**Addendum No. 2
February 18, 2020**

Project: Redfield Public School Addition
Redfield, South Dakota
Project No.: 2610

Architect: Architecture Incorporated

SD-001

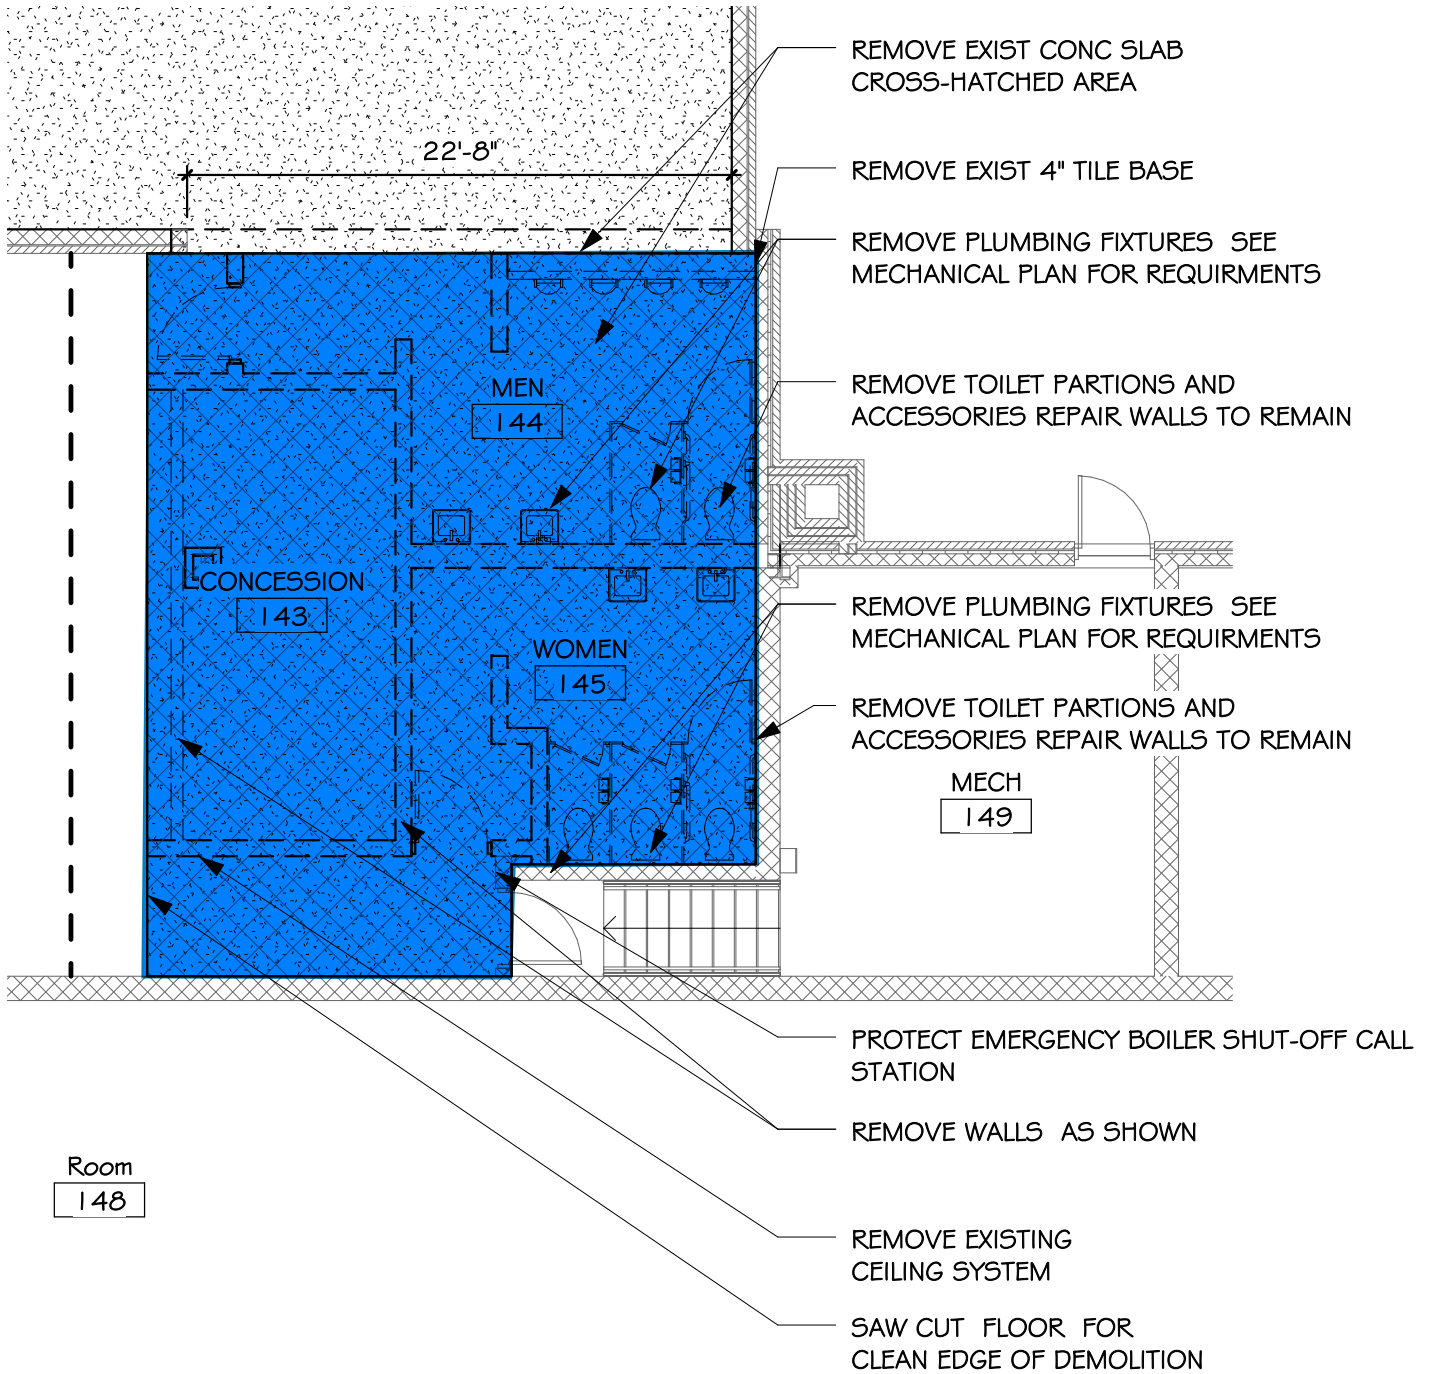
SHEET 4.10 - WEIGHT ROOM DEMOLITION PLAN:

1. Remove existing 4” concrete slab within cross-hatched area and highlighted in blue as shown in the attached SD-001
